## Application for Works Approval

<b>Works Approval Number</b>	W3093/2025/1
<b>Applicant</b>	Brightstar Resources Limited
<b>ACN</b>	100 727 491
<b>File number</b>	APP-0029938
<b>Premises</b>	Beta Gold Mine  Legal description Within the mining tenement M38/009 As defined by the premises maps attached to the issued works approval
<b>Date of report</b>	21 May 2026
<b>Decision</b>	Works approval granted

Figure 2: Beta Gold Processing Plant Layout

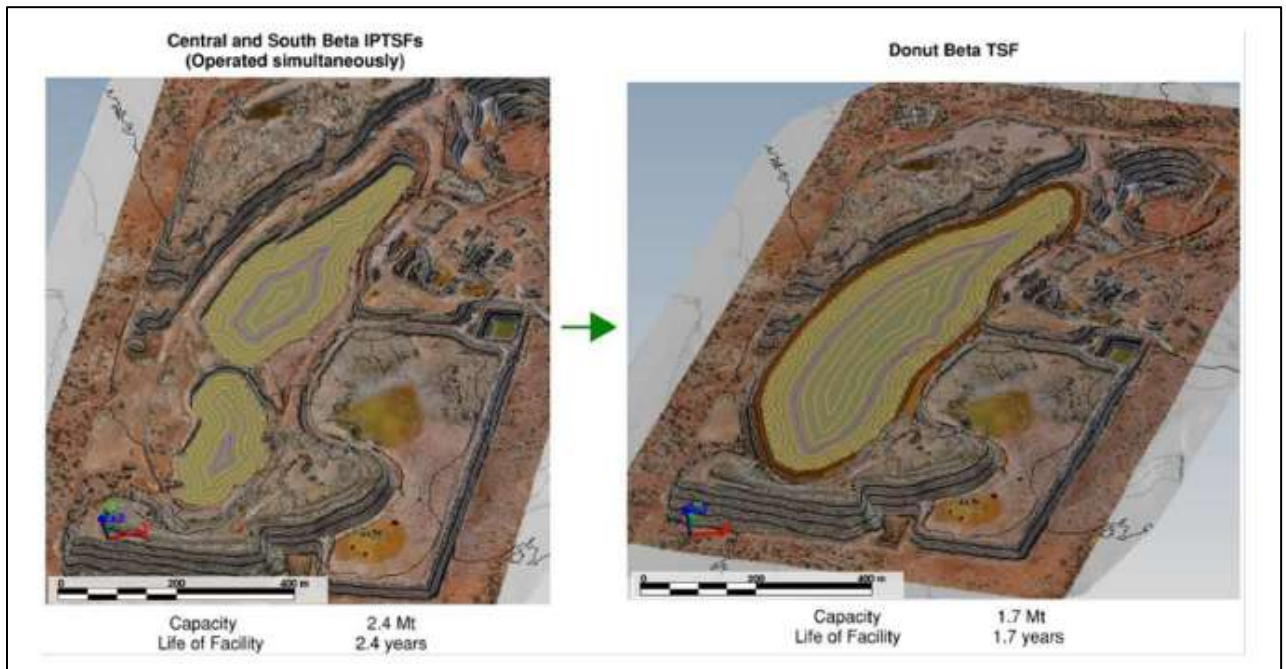
<p>Section 2.3.1 of the Decision Report <u>Beta Gold Processing Plant (BGPP)</u></p> <p>Department requested an updated process plant layout to reflect the updates requested after the application submission.</p> <p>The requested updates include an increase of the throughput to 1.5 Mtpa from 1 Mtpa, and to remove secondary and tertiary crushing, and replace the ball mill with a SAG mill and pebble crusher.</p>	<p>An updated version of the layout was submitted.</p>	<p>The applicant has submitted an updated processing plant layout, and this information has been incorporated into the revised draft decision report and works approval.</p>
<p>The department assessed potential seepage and overtopping risk of the Turkey’s nest. However, there were no</p>	<p>The applicant has stated that the decant water pipeline will connect to the process water pond rather than the</p>	<p>Detail has been updated and this change has been assessed.</p>

<p>d) Plant infrastructure to be installed on a concrete hardstand and constructed in accordance with the design drawing labelled as Figure 2;</p>	<p>Applicant requested to replace “hardstand” with “footings”.</p>	<p>Updates made to plant components in condition 1</p>
<p>c) Multiple spigots to be installed around pit rim;</p>	<p>Suggestion is to change wording to “Spigots to be installed around pit rim”</p>	<p>Change has not been accepted. Design report indicates multiple spigots will be installed.</p>
<p>d) Pontoon-mounted decant pump or land based pump and turret to be installed for decant water recovery</p>	<p>Requested to change wording into “Pontoon-mounted decant pump or land based pump and turret to be</p>	<p>Wording has been updated.</p>

Figure 5: Additional Monitoring bores proposed by the Applicant

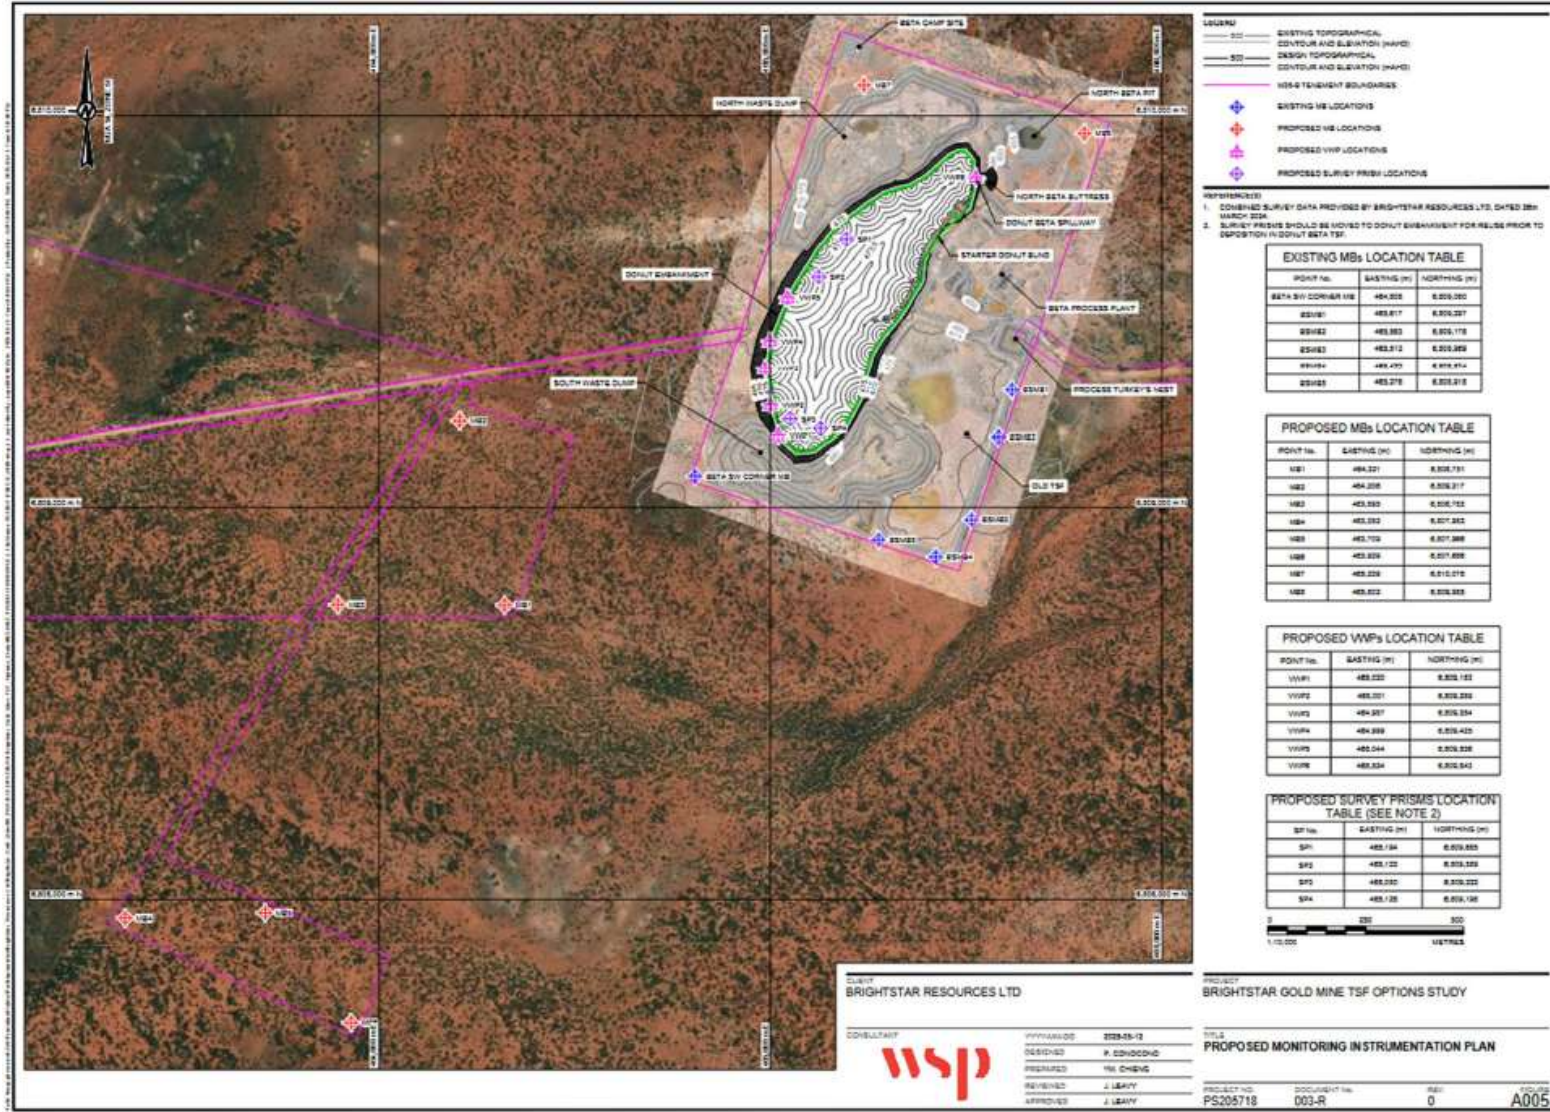
The department notes that the six existing monitoring bores do not provide enough coverage to detect seepage from storing tailings in the TSFs. In response, the applicant has proposed to install eight additional bores, six downstream (off-tenement) and two upstream, to improve coverage and identify any seepage (Figure 5).

Currently, six monitoring bores are located along the southern and southwestern boundary of the tenement. As these bores do not provide full spatial coverage, the applicant has proposed installing eight additional bores in upstream, downstream, and lateral positions to improve monitoring and detect potential seepage.

The Delegated Officer considers the proposed monitoring network insufficient to fully capture potential seepage pathways from the TSFs. Based on expected groundwater flow patterns and potential mounding, the department has determined that at least two additional bores must be installed west of the donut TSF, along the western edge of the tenement (Figure 6). These bores

will enhance coverage in an area where seepage could migrate laterally and affect vegetation. Early identification of changes in groundwater levels or quality in this area will support timely management actions and help prevent environmental impacts. Construction of the additional monitoring bores and requirements have been included in the Works Approval.
